SUBJECT: VL500™ Wash Luminaire Software Update	SERIES: 500
DISTRIBUTION: Service Centers, End Users	STATUS: Routine

Embedded Software Update

Software update **01/21/06** for **VL500™ Wash luminaires** (all versions) is now available. This technical bulletin covers all changes in this new version.

Figure 1-1: VL500A™ Luminaire Menu Display

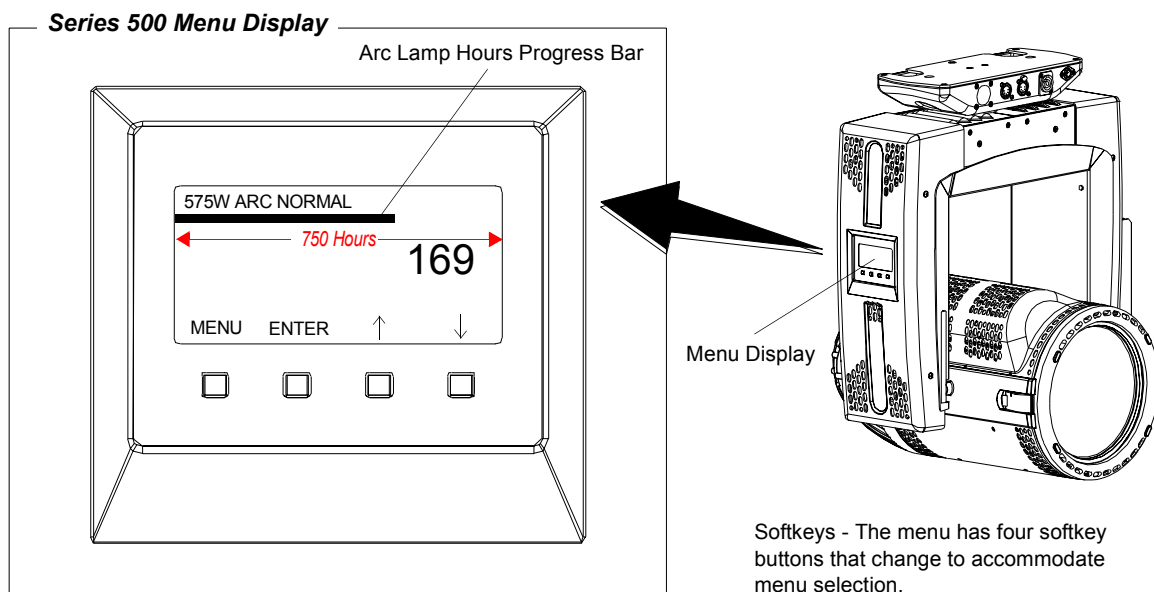
- The menu display shows which lamp type is currently selected on a status line.
- For arc models, there is now a Lamp Hours Progress Bar representing lamp hours used on the lamp. It is tied directly to the lamp hours within the MCB. The bar, when fully extended

across the full width of the menu display, represents 750 lamp hours (as indicated in **Figure 1-1**). Resetting lamp hours will reset progress bar. This bar is only for a quick graphical representation of the lamp hours used. For actual lamp hours used, please read the note below.
